STEP BY STEP EARLY LEARNING CENTER

JULY 09, 2024

1st Review
PRCCP20241109
August 2024

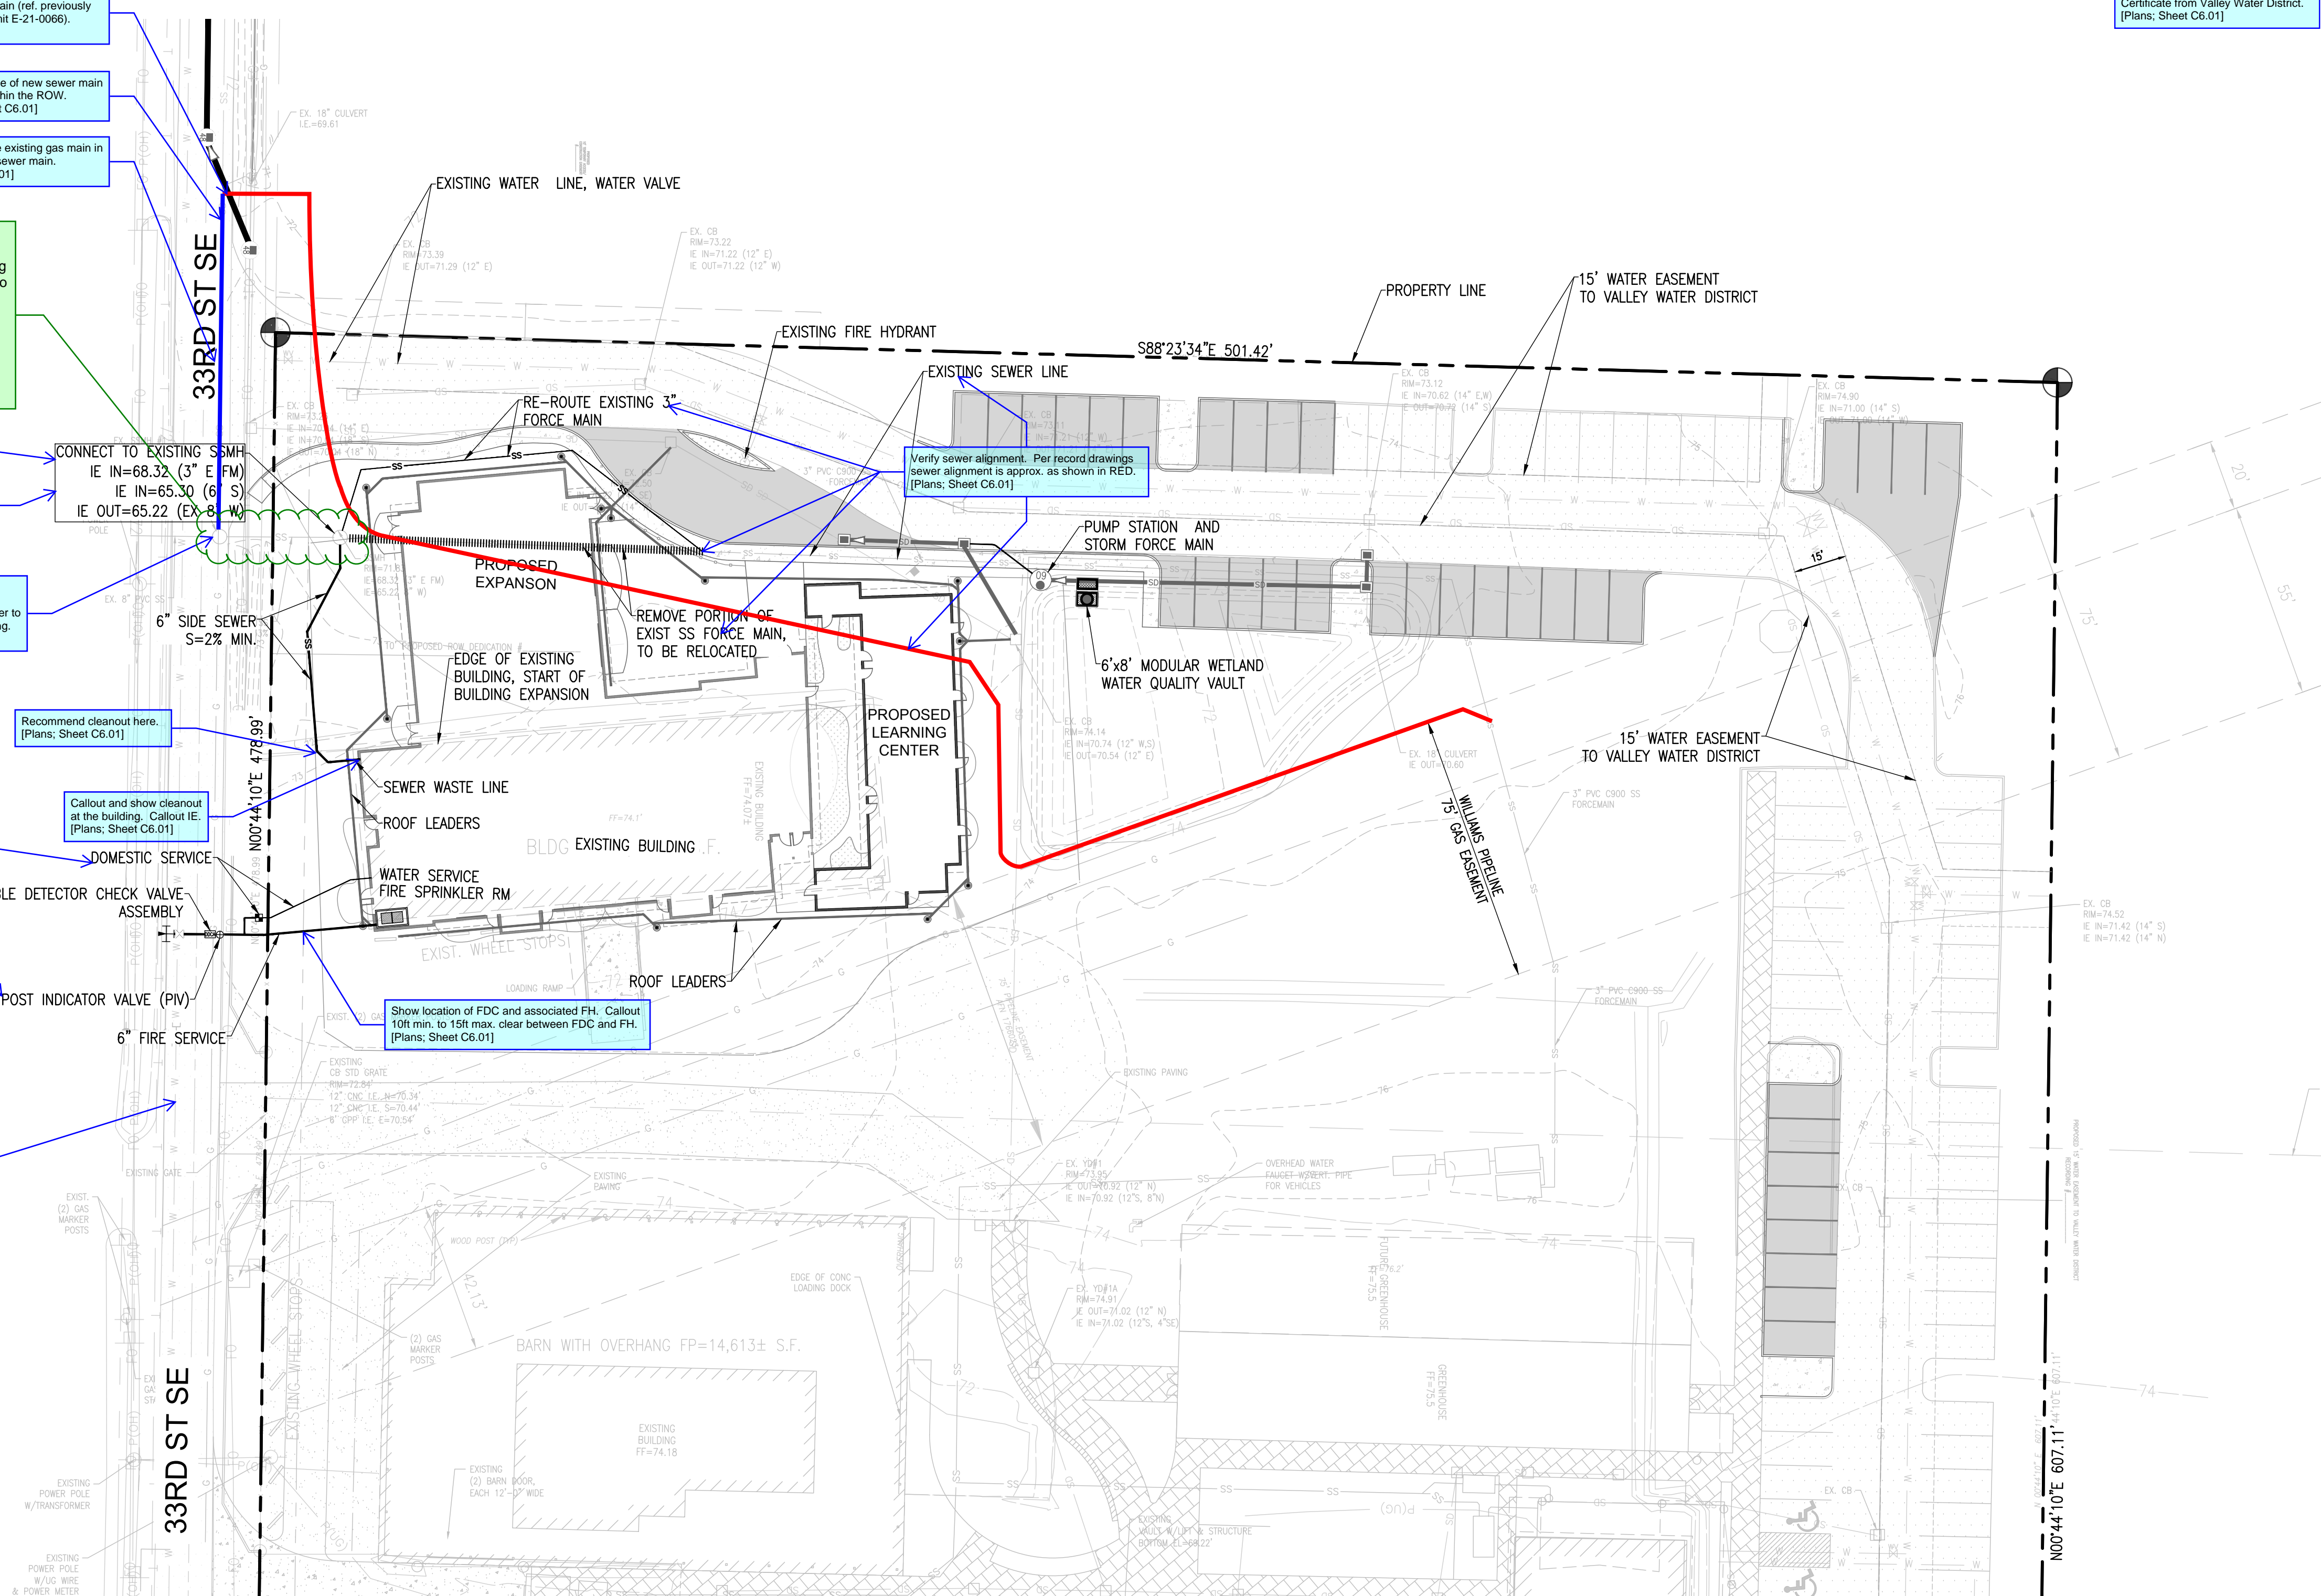
Add City Fire Code Official approval block and Water Purveyor approval block to this sheet. See City Standards Section 1.4. [Plans; Sheet C6.01]

Provide an approved Water Availability Certificate from Valley Water District. [Plans; Sheet C6.01]

- Callout to remove existing temporary cleanout and extend new sewer main (ref. previously approved drawings, Permit E-21-0066). [Plans; Sheet C6.01]

- Provide profile of new sewer main extension within the ROW. [Plans; Sheet C6.01]
- Callout to relocate existing gas main in conflict with new sewer main. [Plans; Sheet C6.01]

- This manhole installation has never been constructed. The existing force lateral discharges to a sanitary cleanout, continues north and connects to the existing city system north of the driveway entrance. [Civil Plans; C6.01]

- Provide new sewer manhole (currently not constructed). Specify interior of forcemain discharge manhole to be lined with Raven 45 epoxy or approved alternative. [Plans; Sheet C6.01]

- Provide connection detail of the forcemain to new sewer manhole (see previously approved permit drawings, E-21-0440). [Plans; Sheet C6.01]
- Install new sewer manhole with 8-inch sewer stub to Parcel 0420264019 and new side sewer to Step-by-Step. Callout stationing. [Plans; Sheet C6.01]

- Recommend cleanout here. [Plans; Sheet C6.01]
- Callout and show cleanout at the building. Callout IE. [Plans; Sheet C6.01]
- Relocate to private property (3 pics). [Plans; Sheet C6.01]

- DOUBLE DETECTOR CHECK VALVE ASSEMBLY
- POST INDICATOR VALVE (PIV)
- 6" FIRE SERVICE
- Clearly identify City of Puyallup's and Valley Water's individual watermains. [Plans; Sheet C6.01]

C6.10

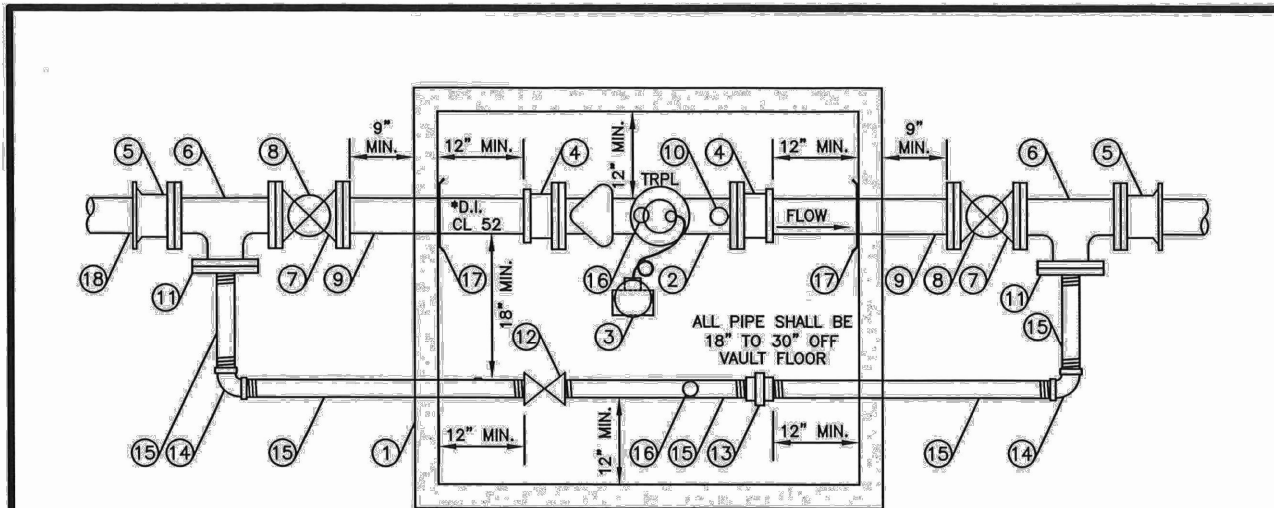
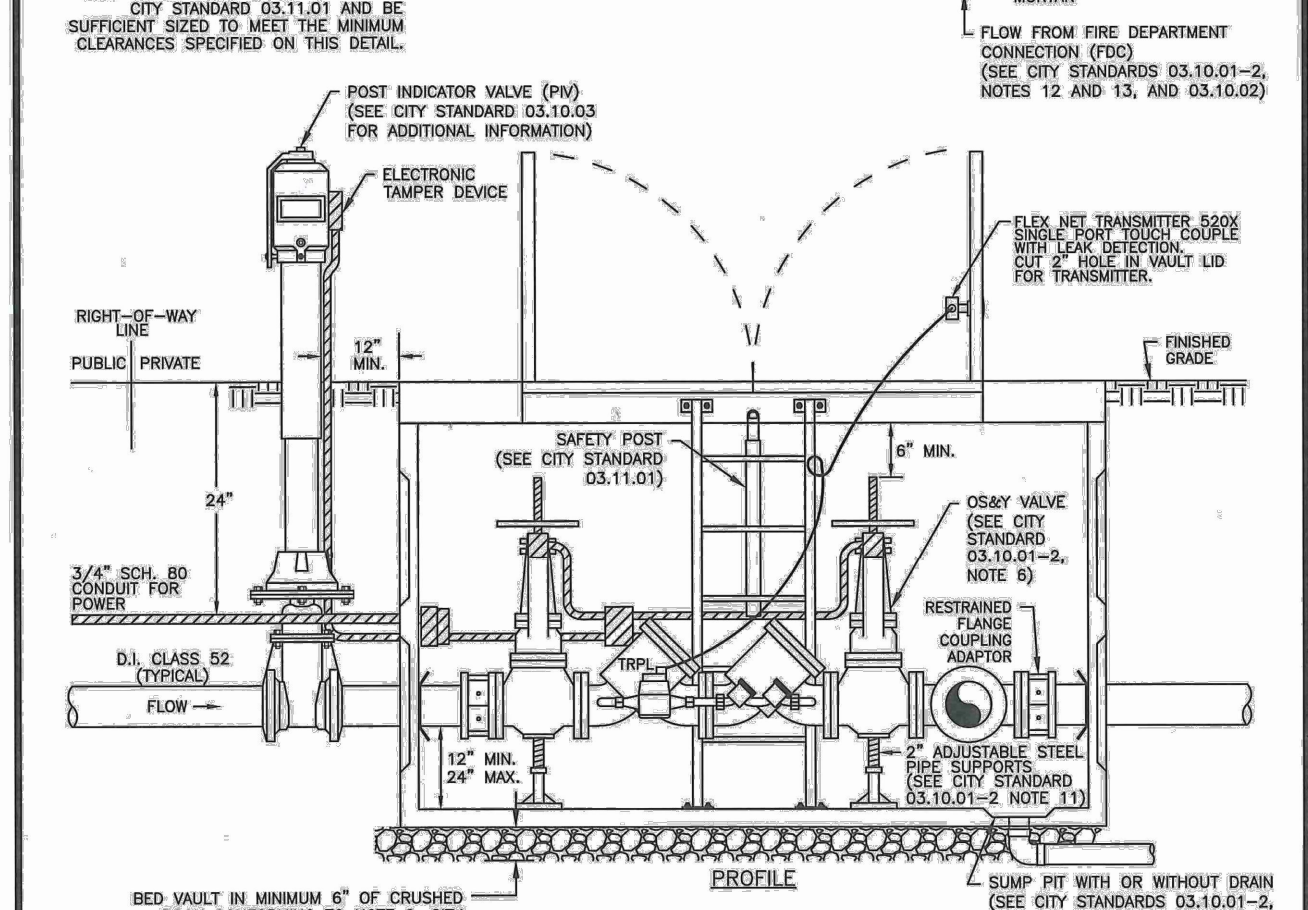
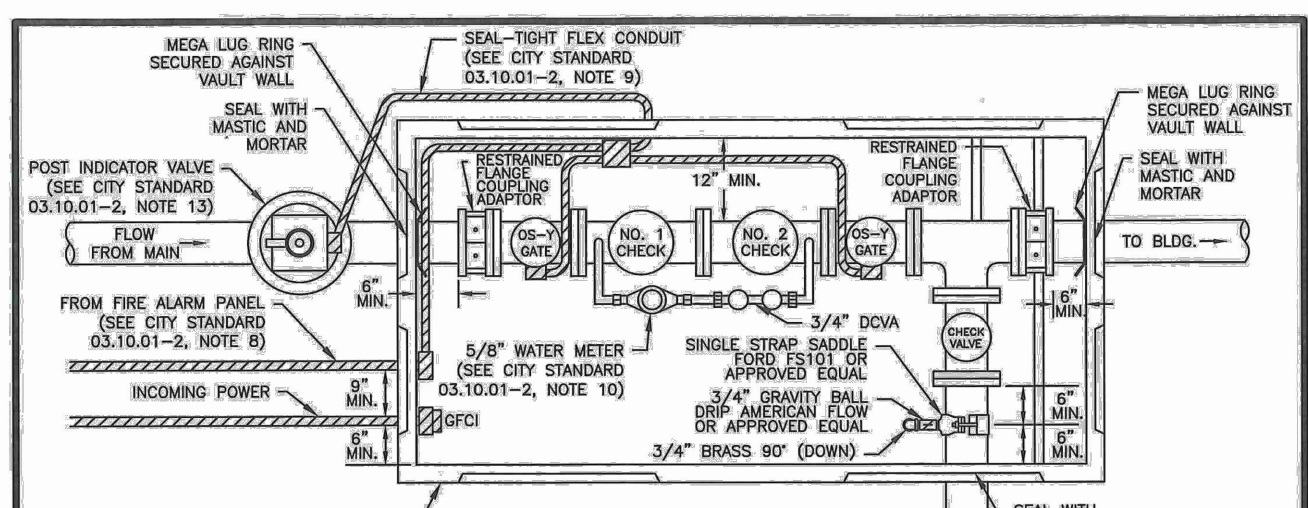
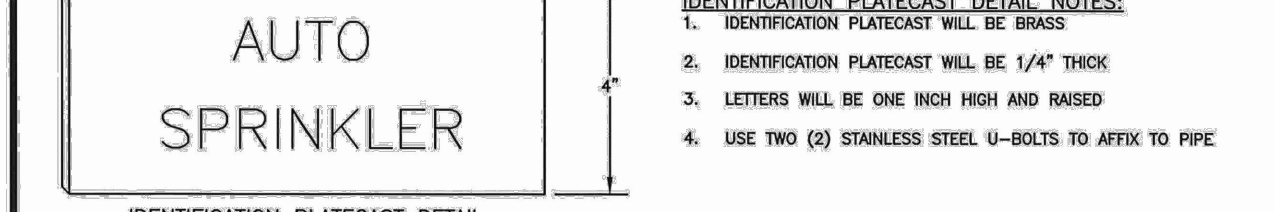
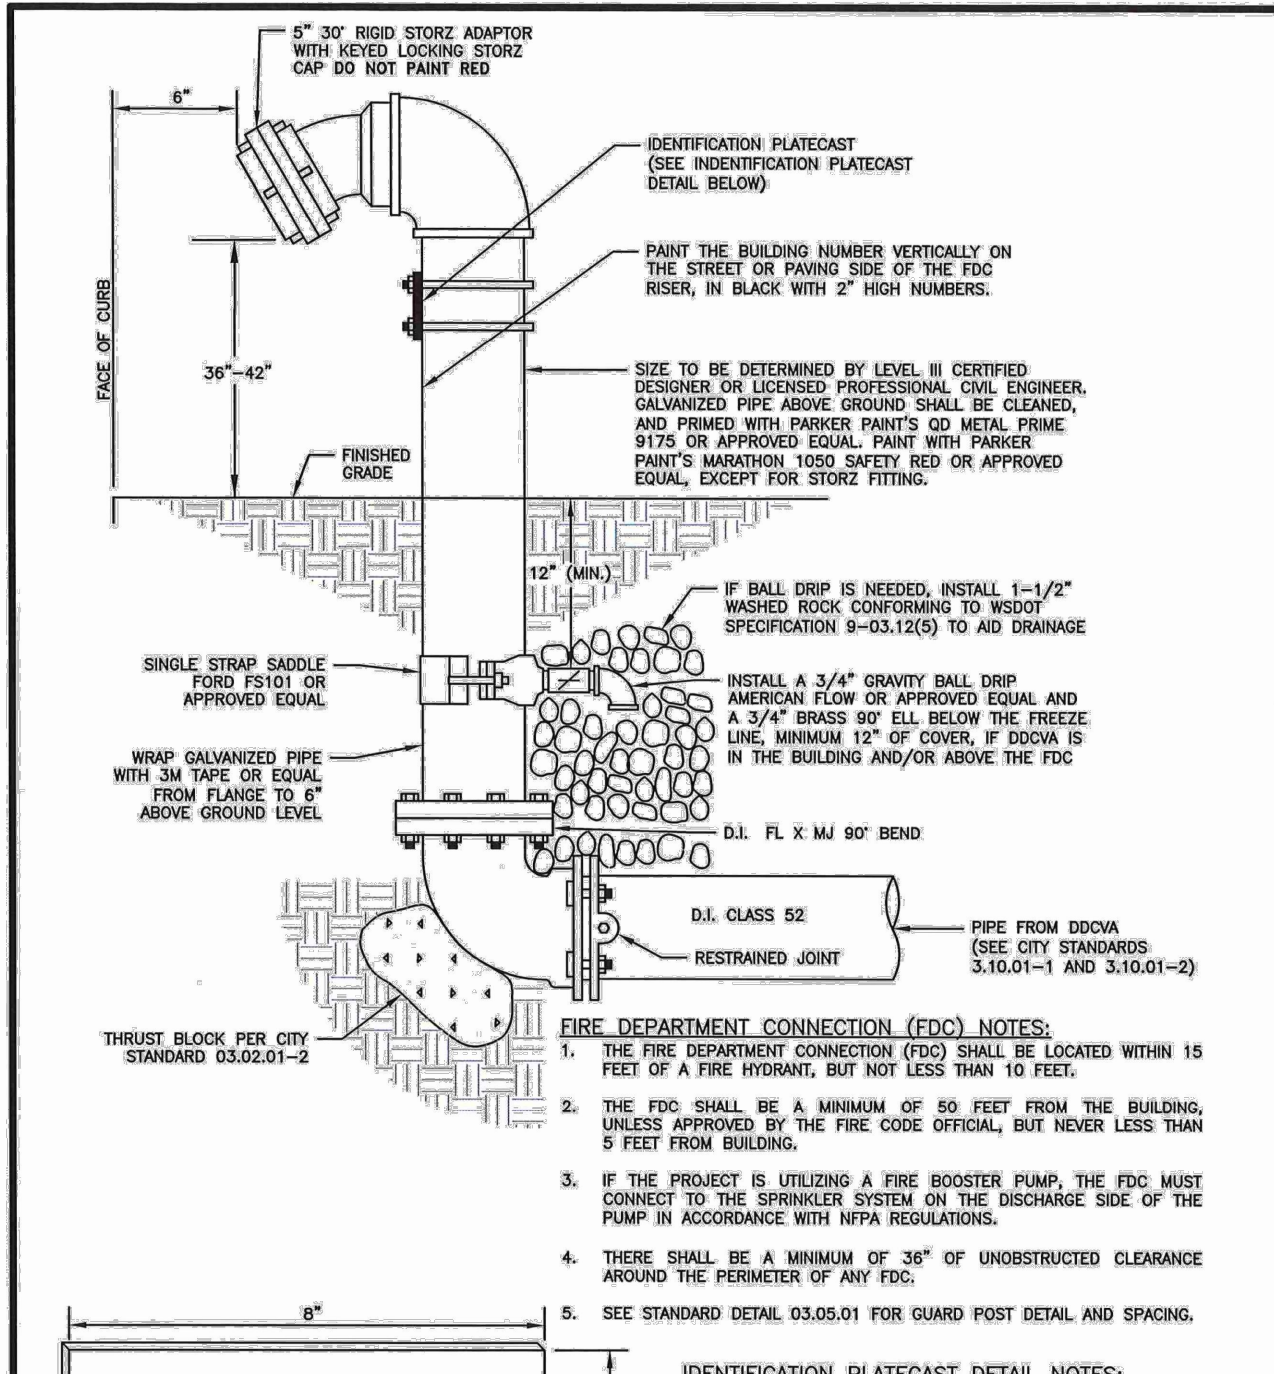
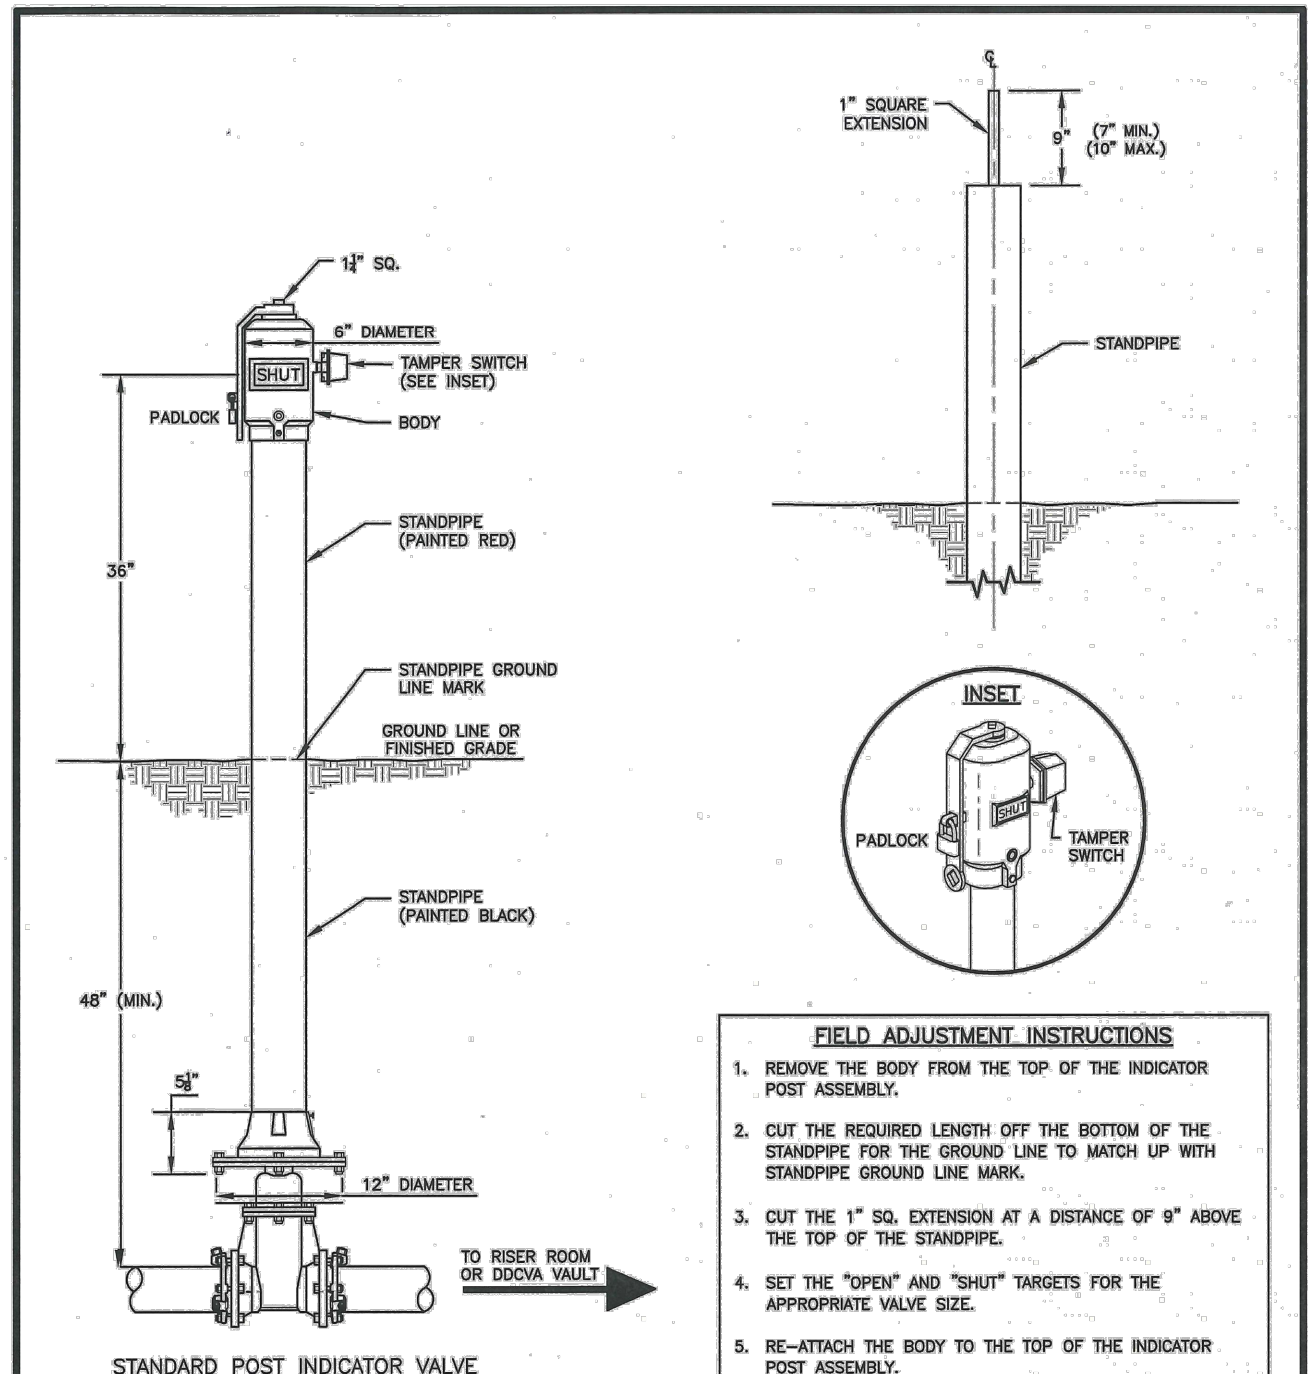
Add City Standard Details:
03.05.01 // 03.11.01 // 04.03.05 //
[Plans; Sheet C6.10]
